# **RULE NO.: R161-22.12**

#### NOTICE OF PROPOSED RULE

R161-22.12: Proposed revision to Standards 512-AW-01, 512-AW-02, and 520S-17

# SUMMARY OF 4<sup>th</sup> QUARTER - 2022 STANDARD

512-AW-01

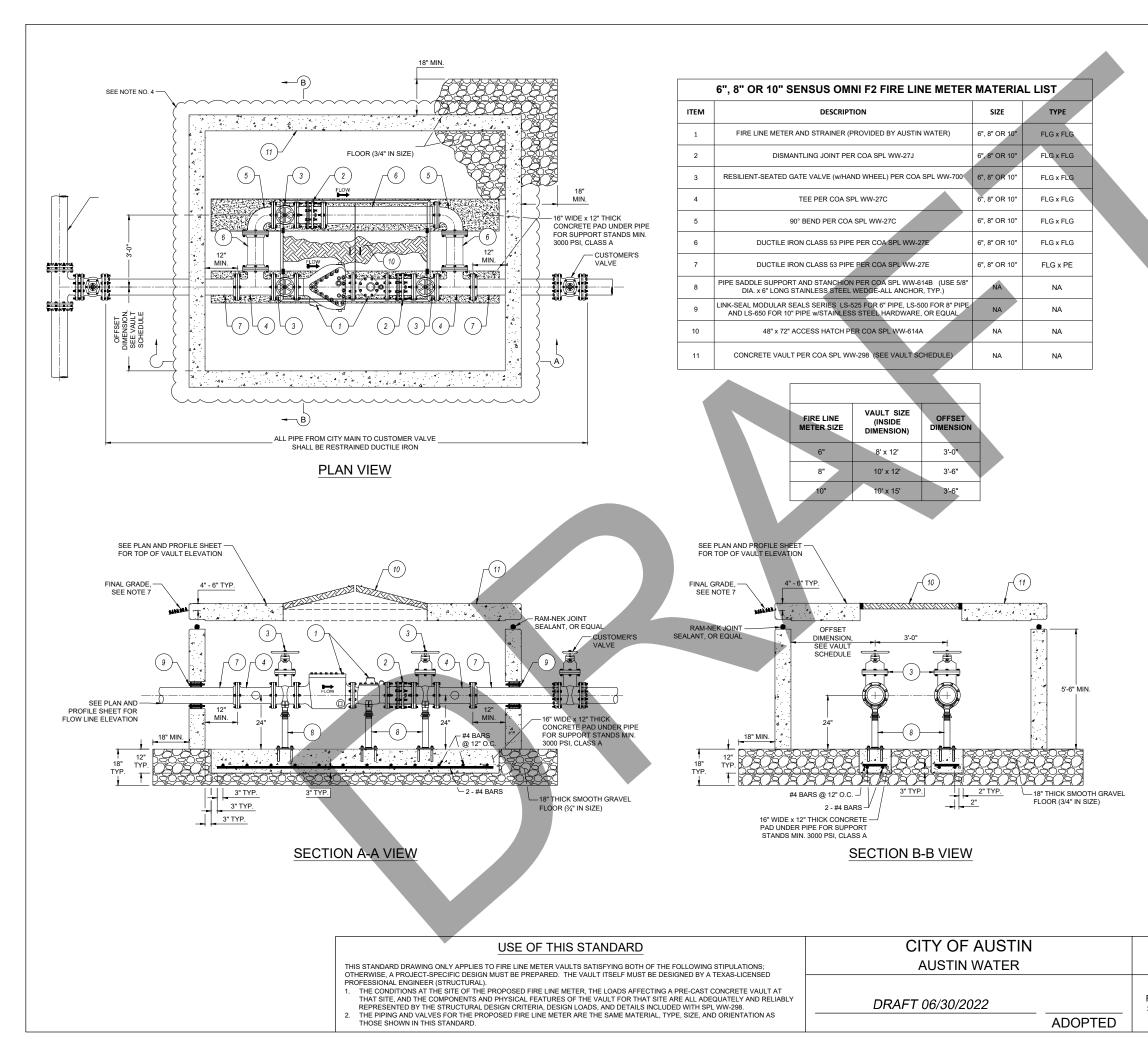
- 1. Standard 512-AW-01 Create a new Standard for Dual PRV Stations.
- 2. Standard 512-AW-02 Create a new Standard for Fire Lines Meters.
- 3. Standard 520S-17 Discontinue this Standard as it is being replaced with Standard 512-AW-02.
